A G E N D A

Architectural Review Board

July 27, 2021 – 5:30 p.m.

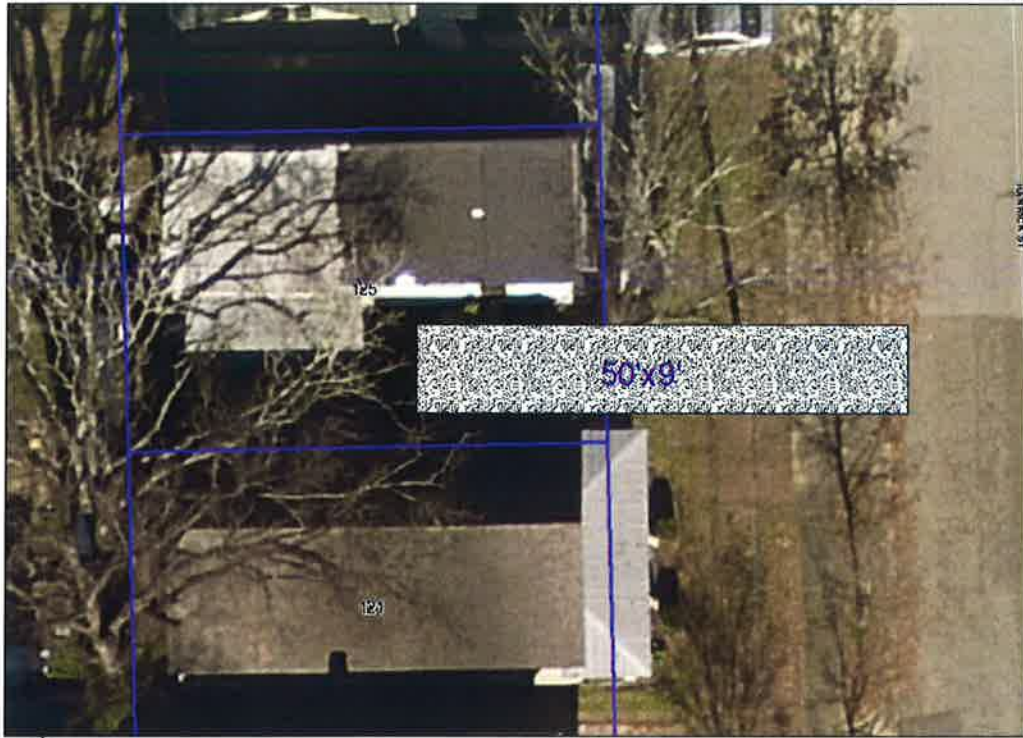
- No objection to the tree removal by Urban Forester subject to the payment of a mitigation fee based on the size and species of the tree.
- UF recommends replacing with a canopy tree species, palms are not trees.

4A

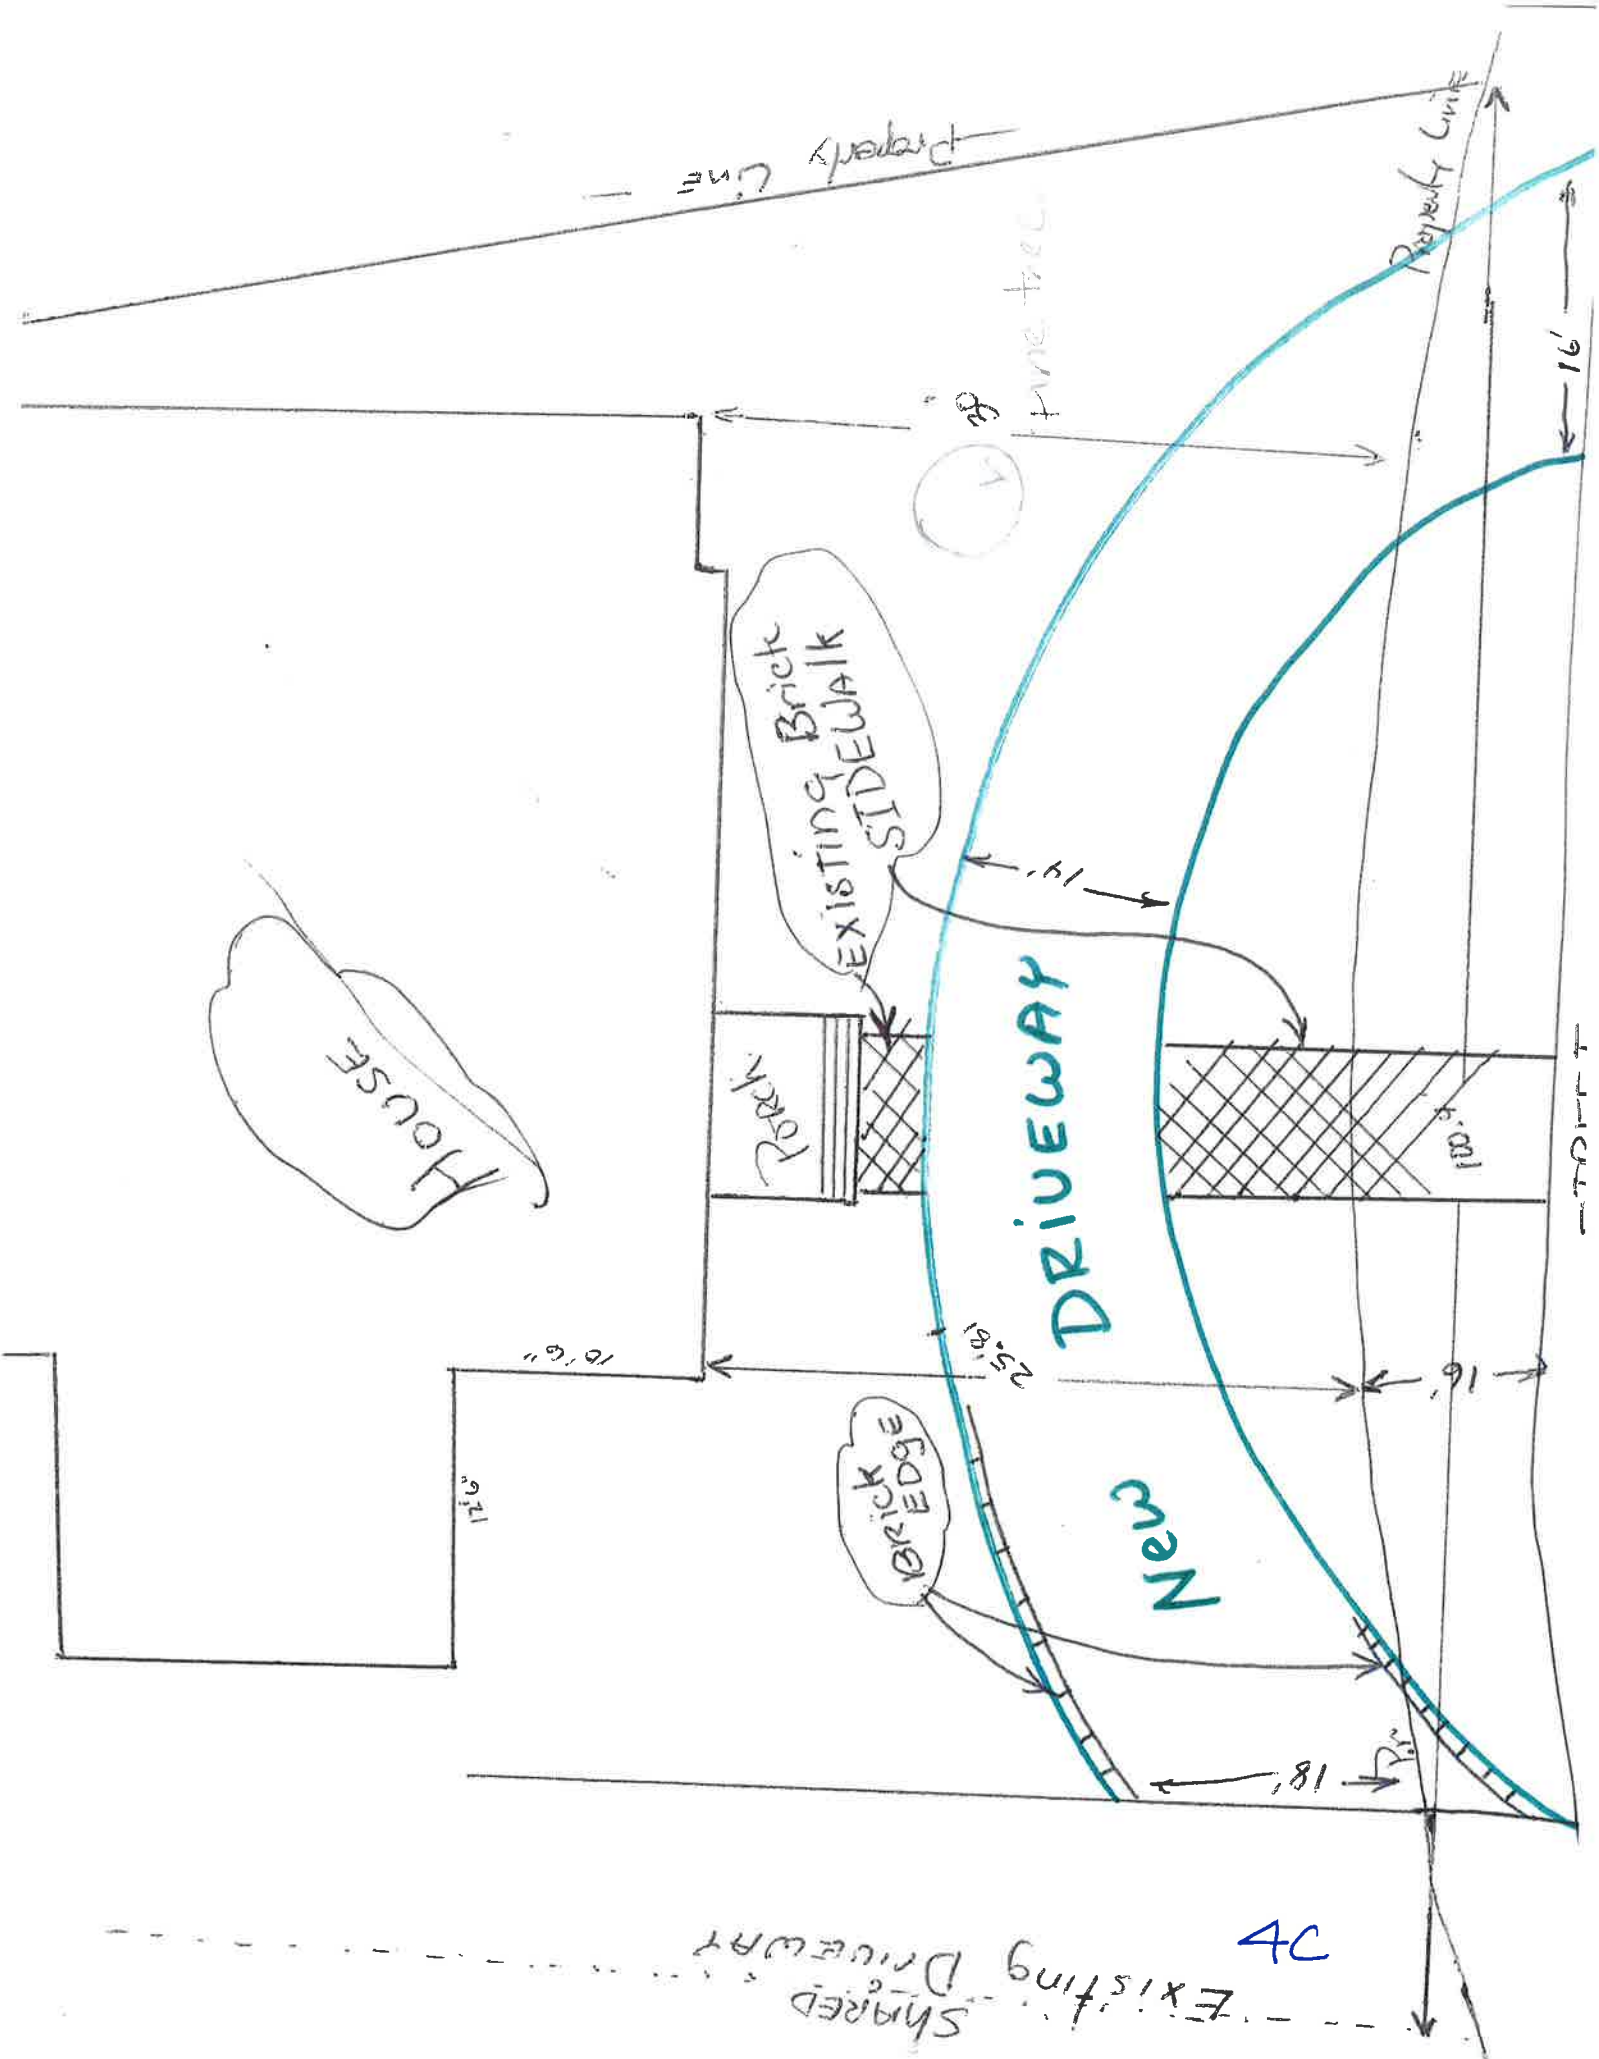
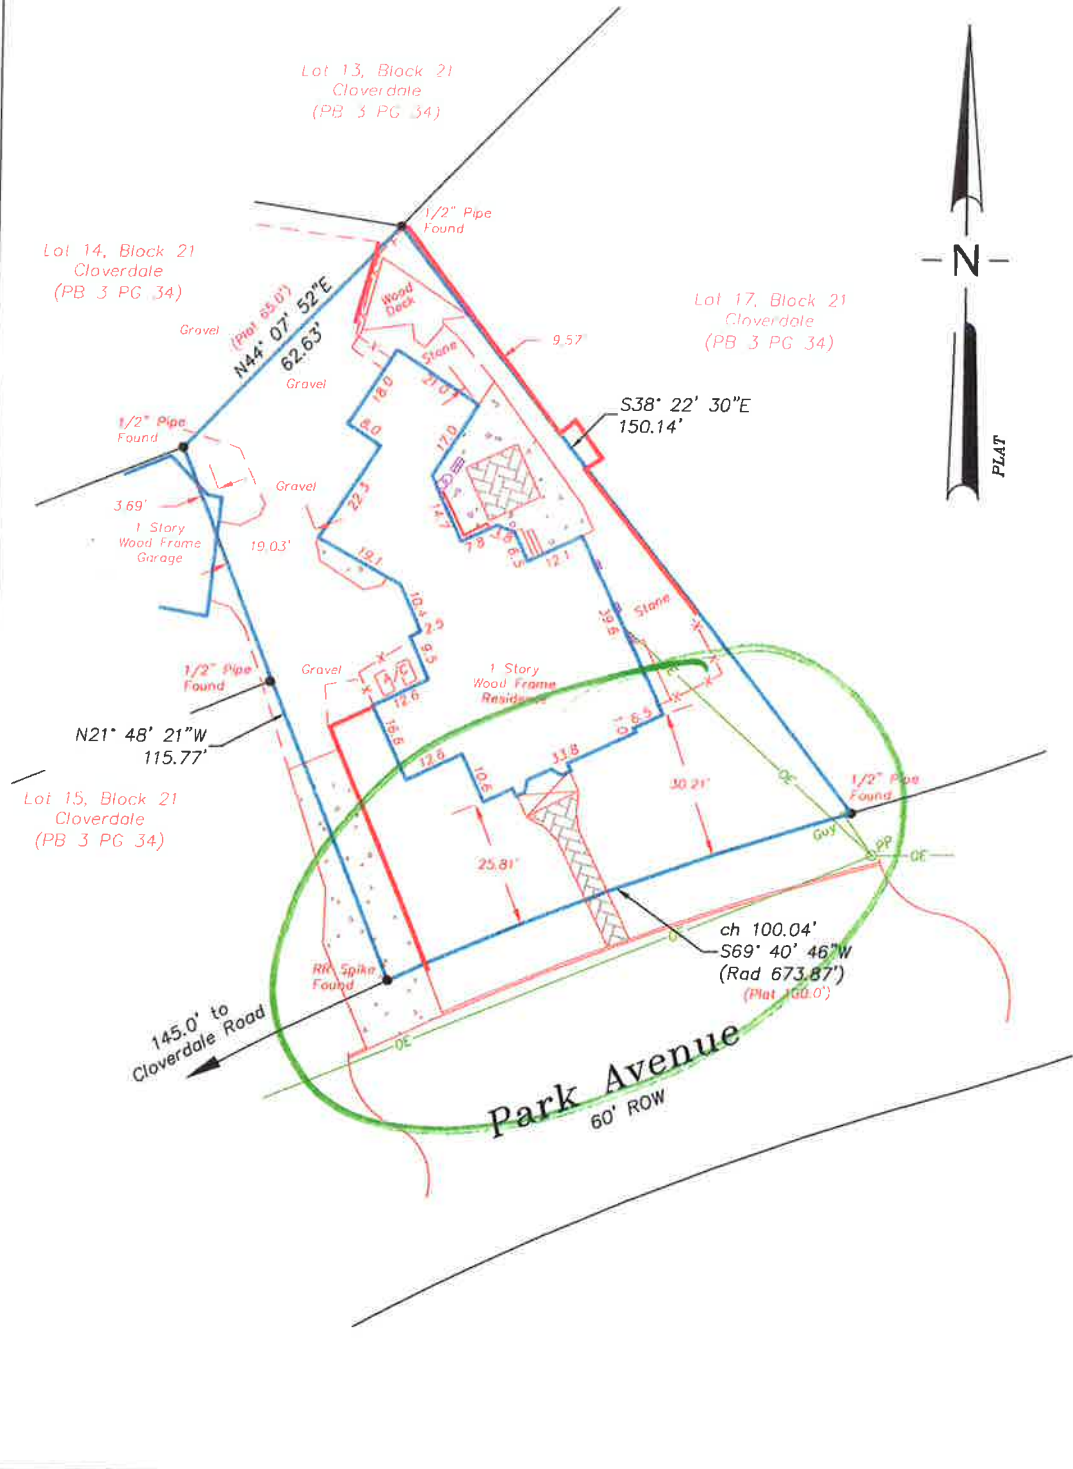
- Widening the existing driveway to create parking spaces off to the side of the front door for this property would be far less visually intrusive than a circular drive in a very small front yard. Paving will take up a good portion of the green space.
- 14' is wider than the circular drive approved at 740 Felder, where 12' was proposed and 10' was approved.
- Item #6 on this agenda previously requested a circular driveway that was denied and the yard was larger, the Board later approved an off-set parking plan.
- Landscape materials should be specified, and to fully provide screening would need to include installation of plant material in the right of way, which would require the Urban Forester's approval.
- The plan does not indicate the location of a significant tree and lacks landscape details.

PRELIMINARY PARKING LAYOUT OF 2305 ST. CHARLES AVE., MONTGOMERY, ALABAMA FOR MARITZA VILLACI SCHEME "E"

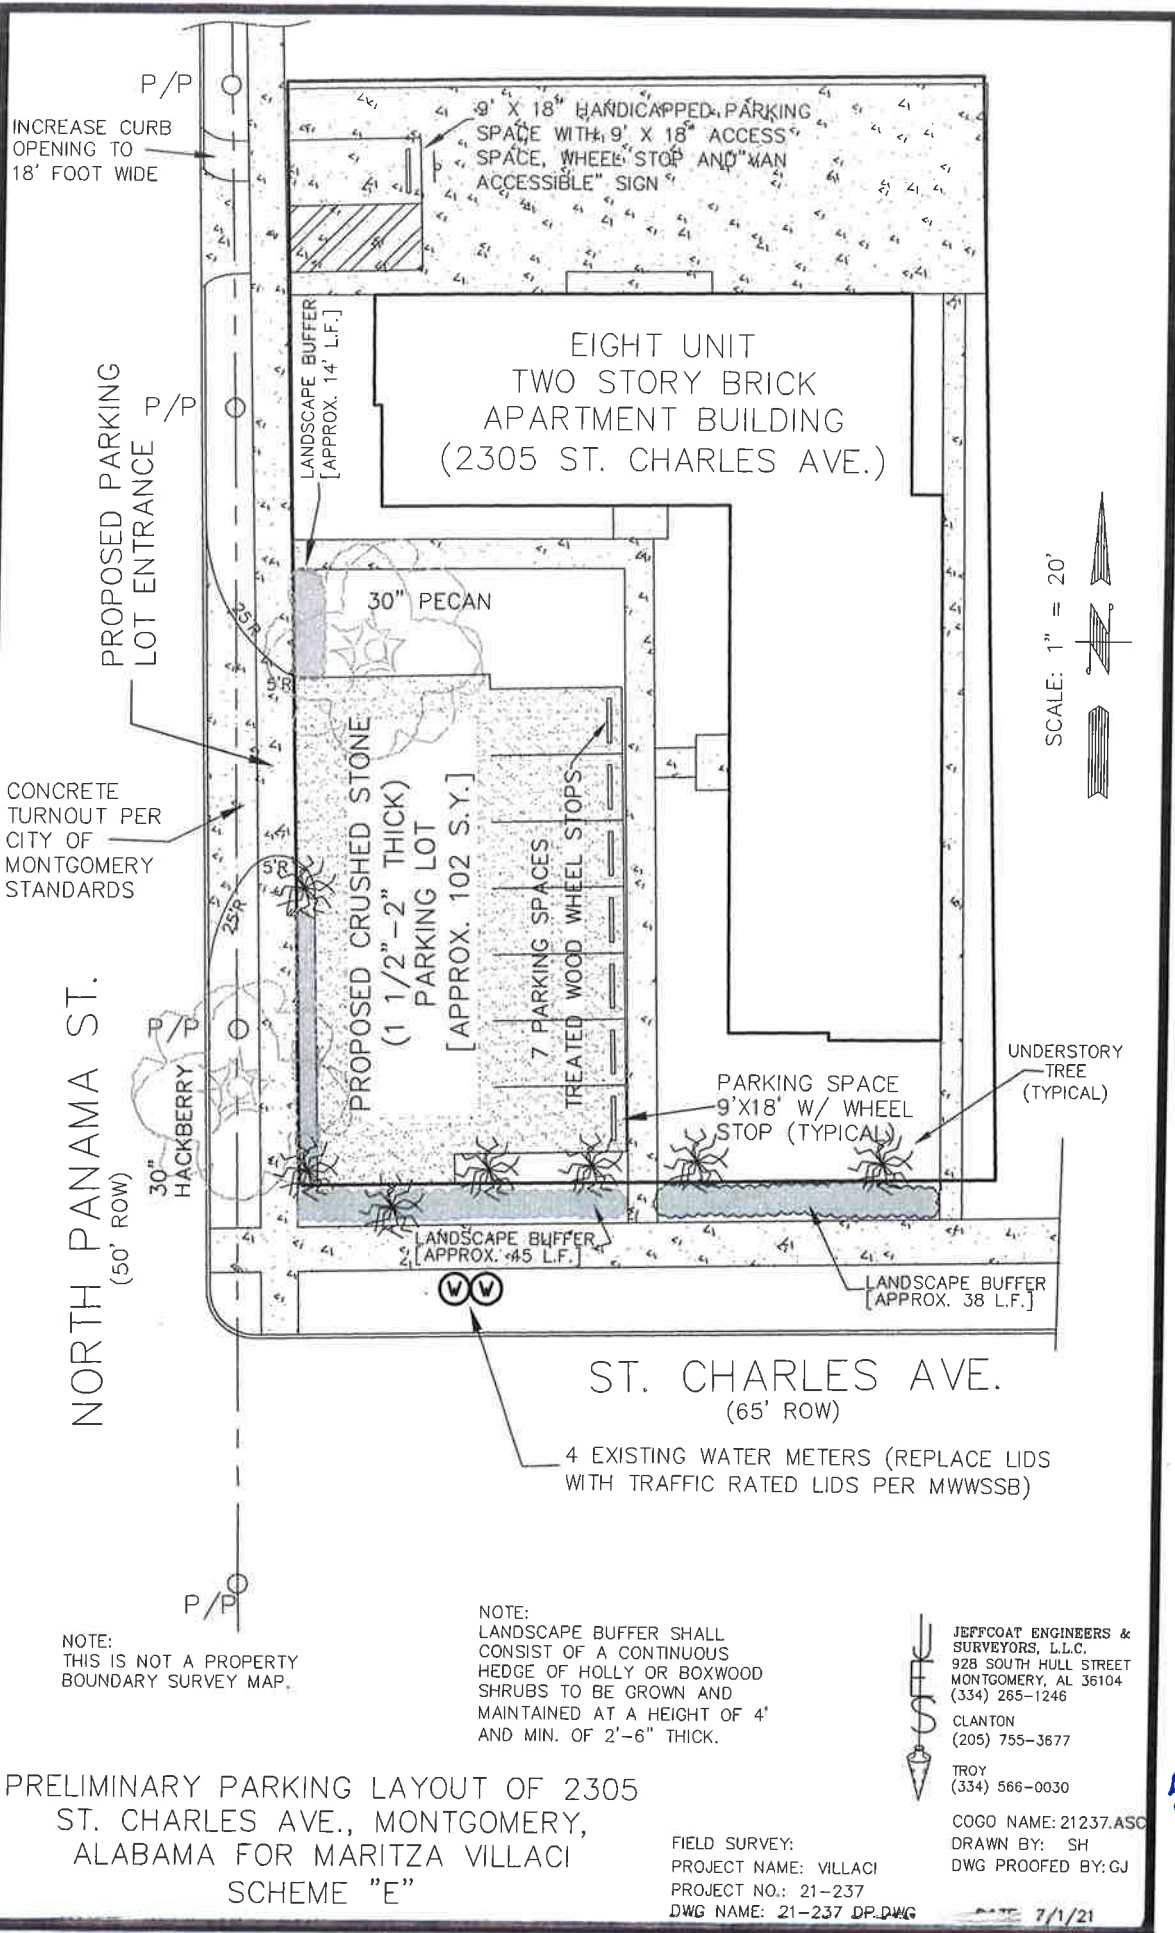
- This property has languished boarded up for many years, and while it is generally not the policy of the ARB to allow the absorption of a front green space for parking, the location presents challenges for other parking options and the relationship of this building to the street is different than a single family residence. It is the opinion of staff that protecting the view from St. Charles will help the new owner to make this property viable.
- Staff notes that it appears new doors have been installed, the owners are reminded that all exterior changes need to come before the board.
- Landscape hedge should follow the City of Montgomery minimum landscaping guidelines, 18” tall at installation spaced no more than 36” apart.

6D

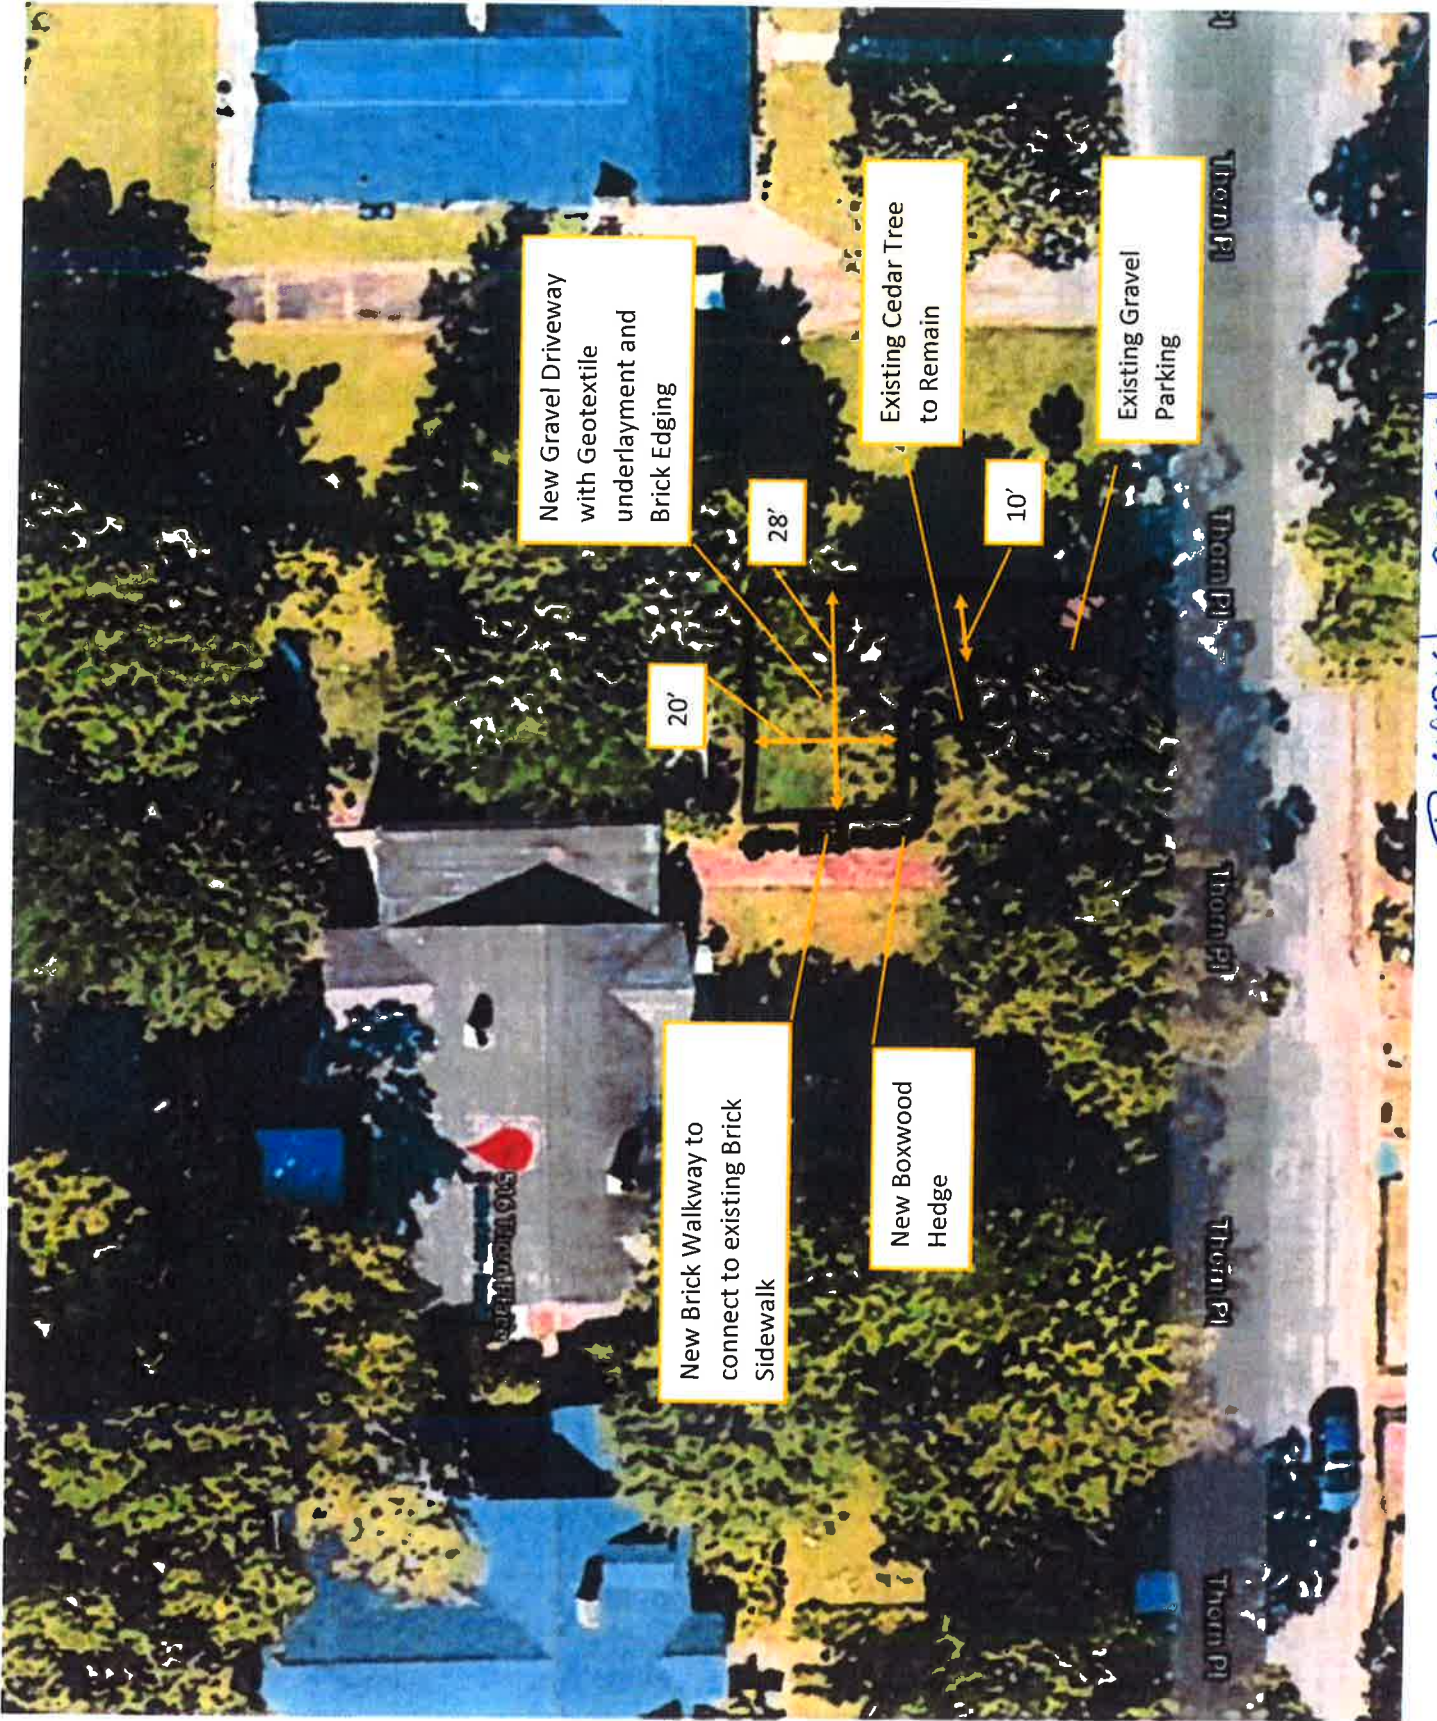
- The Board approved the previous plan as the proposed parking was off to the side and not in front of the house, and geotextile material was proposed around the cedar tree. The Board did not approve the original proposal for a circular driveway.
- No objection from Urban Forestry.
